AEP:NRC:0969AK

Donald C. Cook Nuclear Plant Units 1 and 2
ASME SECTION XI RELIEF FOR REACTOR COOLANT SYSTEM BRANCH
CONNECTION WELDS ADDENDUM

RESPONSE TO A REQUEST FOR INFORMATION
ASME SECTION XI RELIEF
FOR VOLUMETRIC WELD TESTING
OF SELECTED RCS BRANCH CONNECTION WELDS

Figure 1
(Note: Figure Not to Scale)

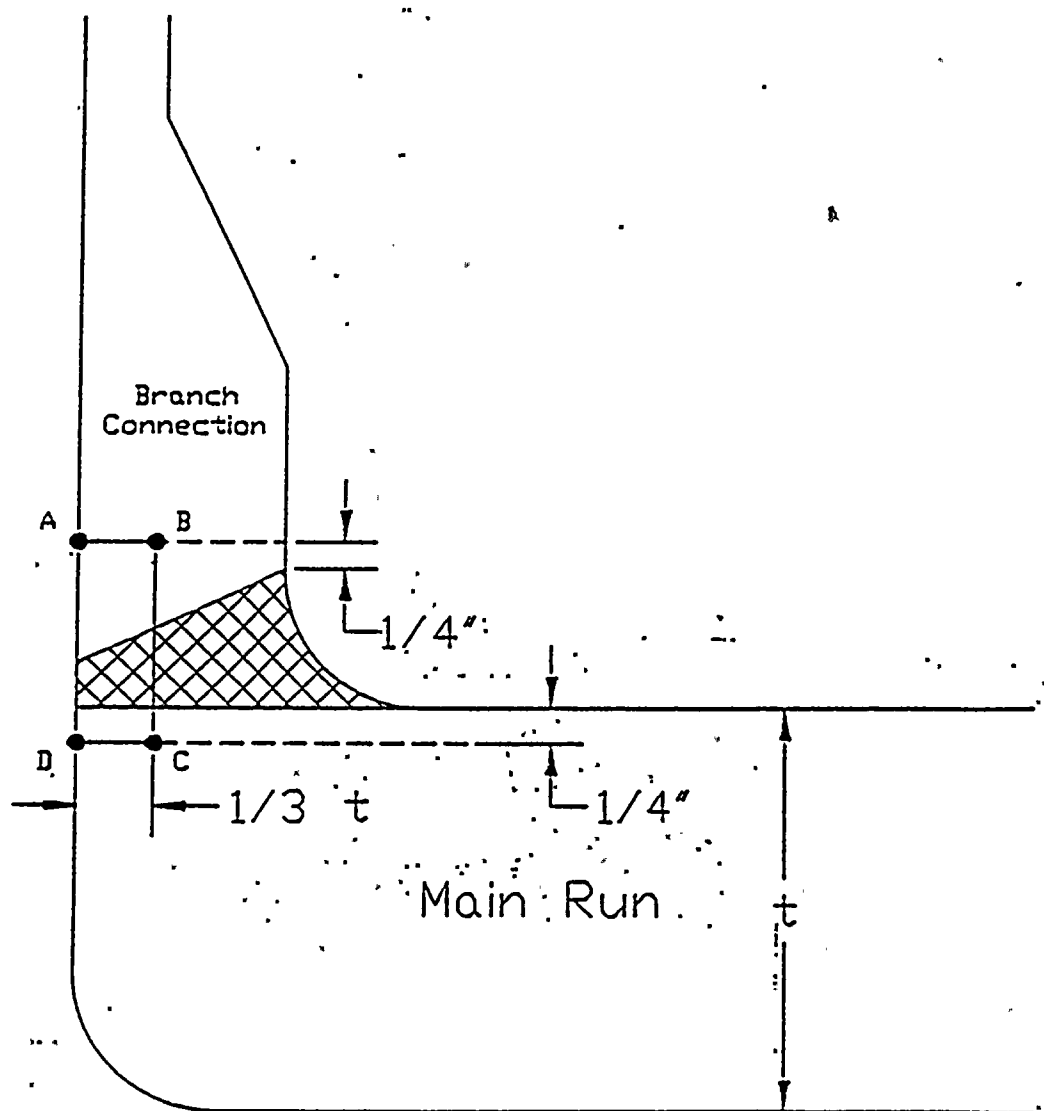
Provide a discussion of the examination results, examination techniques, weld examination coverage and direction of coverage.

In September of 1995, during the last refueling outage of the second 10-year ISI interval for Cook Nuclear Plant Unit 1, three branch connection welds were volumetrically examined, using techniques and procedures based on standard industry methodology, by our vendor Southwest Research.

The RCS branch connections are composed of type 316 stainless steel forged nozzles attached to centrifugally cast stainless steel reactor coolant system piping. The acoustic properties of forged type 316 stainless steel nozzles are excellent while the attenuation characteristics of centrifugally cast stainless steel piping make it extremely difficult to perform an adequate examination from the reactor coolant system piping. Furthermore, the set-on nozzle arrangement with the weld orientation normal to the branch pipe axis precludes weld examination coverage from the reactor coolant piping using code calibration techniques. For these reasons, the examination was conducted from the branch pipe surface adjacent to the weld seam (Appendix III-4100). The code required volume is illustrated in Figure 1 and Table 1 summarizes the techniques, and essential parameters for these examinations. In summary, the ultrasonic examination meets the scan coverage requirements of the 1983 edition of ASME Section XI, through Summer 1983 addenda for reflectors parallel to the weld seam (Appendix III-4420) and for reflectors transverse to the weld seam (Appendix III-4430) with limitations noted in Table 1 (attached). No recordable indications other than geometric reflectors were reported during these examinations.

SWRI procedure DCC-UT56, Rev 0, Chg. 0 was used for the examination of RCS branch piping welds. Sound transmission and examination volume coverage limited on transverse angle beam technique due to weld configuration and pipe geometry. Examined to the extent possible.
